## ORIGINATION FORM

### Proposed Revisions to a Standard Plans Index

Index Number: 700-030

Index Title: Wind and Hanger Beams for Overhead Signs

TYPICAL SIGN FOR OVERHEAD TRUSS

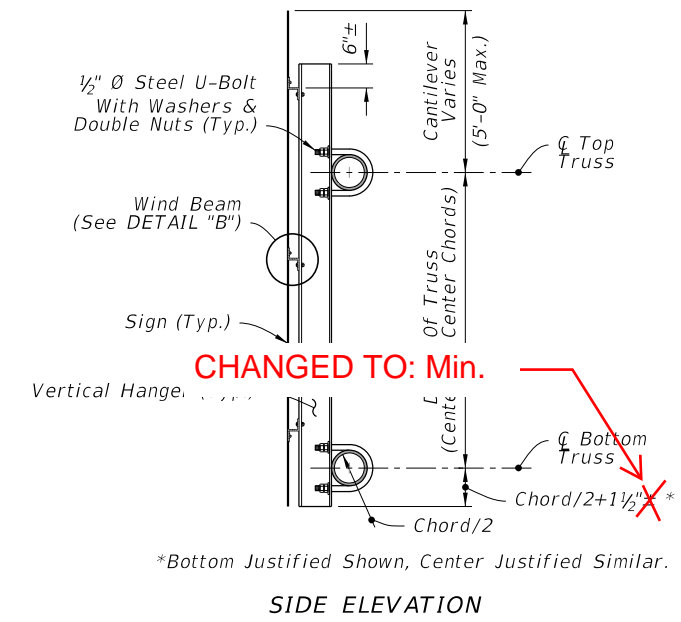
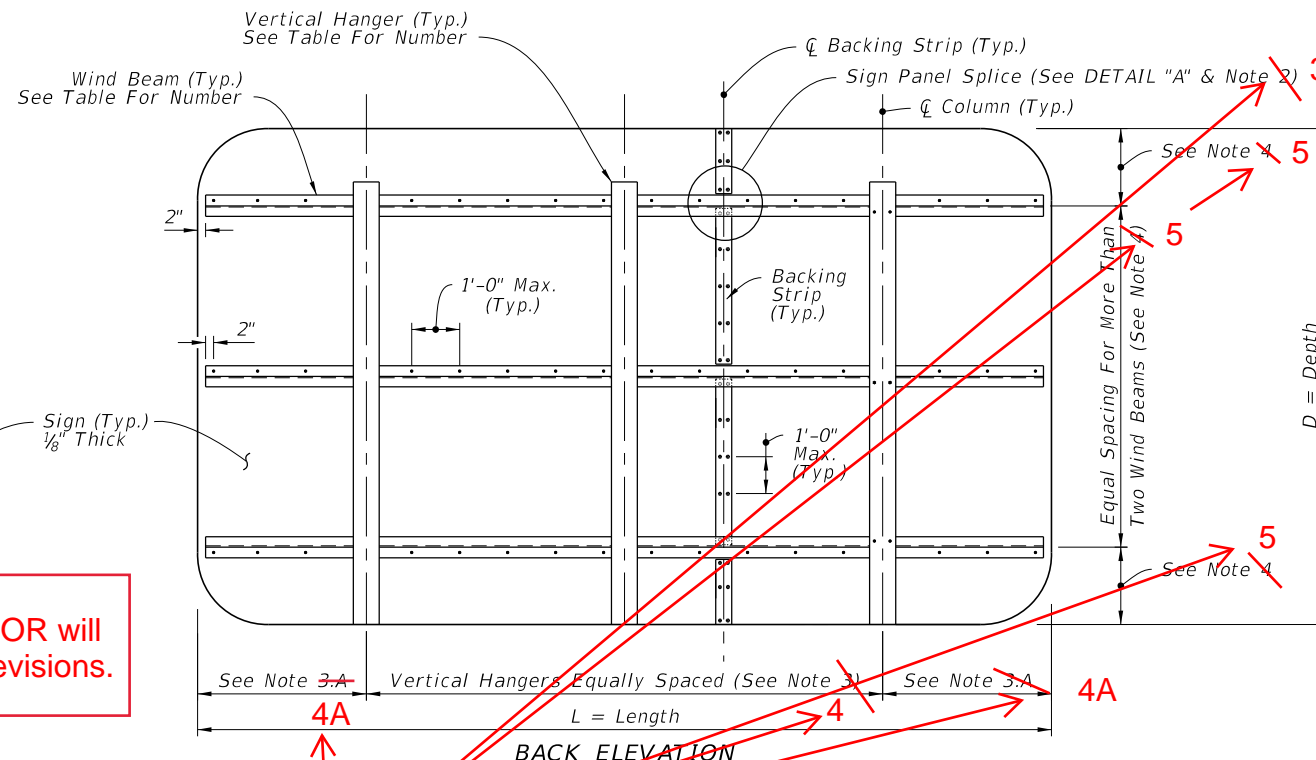
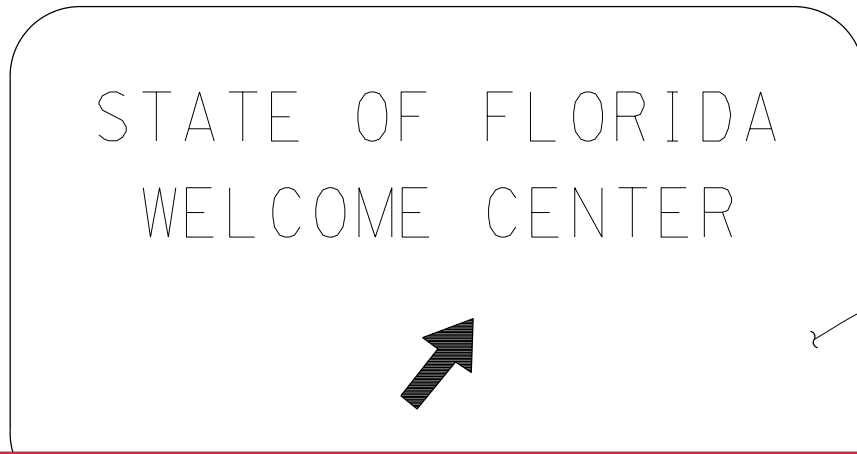
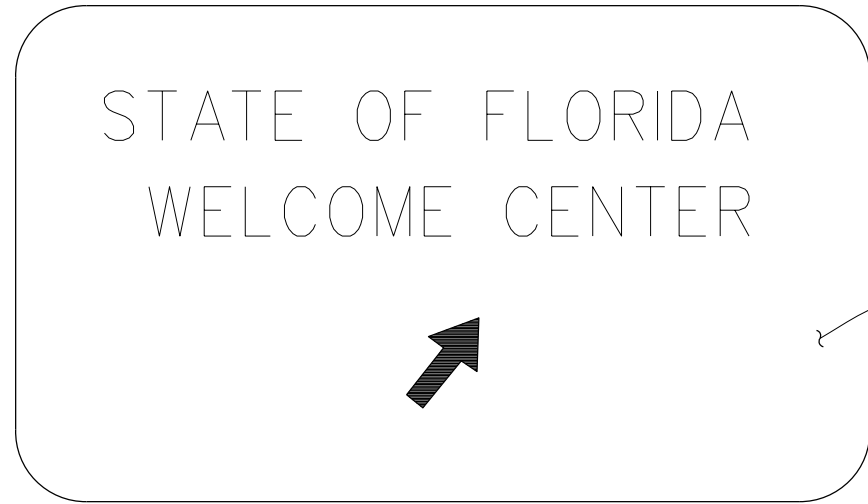
Added New General Note 1 - "Meet requirements of Specification 700."; Deleted Notes 6 and 7; Renumbered Notes; Updated General Note references in the TYPICAL SIGN FOR OVERHEAD TRUSS details; Changed the tolerance symbol "+/-" for the edge distance of the bottom U-bolt to a "Min."

UPDATED: References (See General Note...)

ADDED NEW NOTE 1: Meet the requirements of Specification 700.

DETAIL "B"

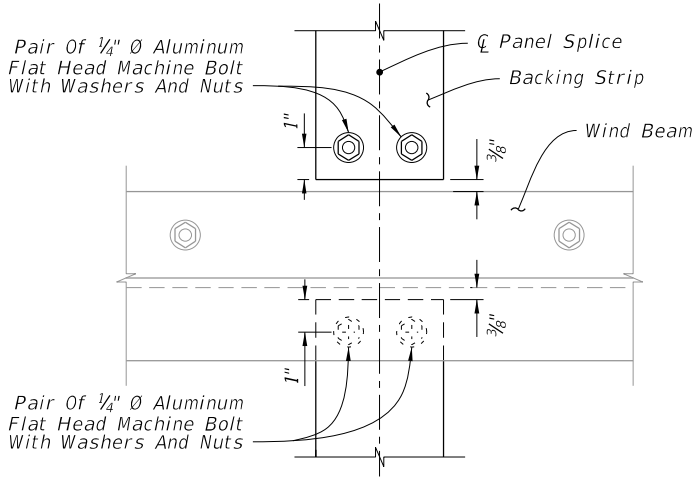
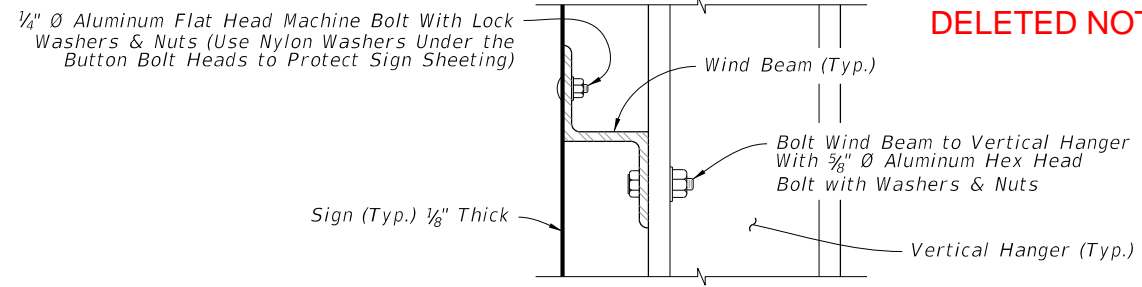
A tolerance of +/- suggests that the 1 1/2" dimension could be less and by some undefined amount. While any additional edge distance would not be structurally significant we wanted to put a lower limit on the edge distance.
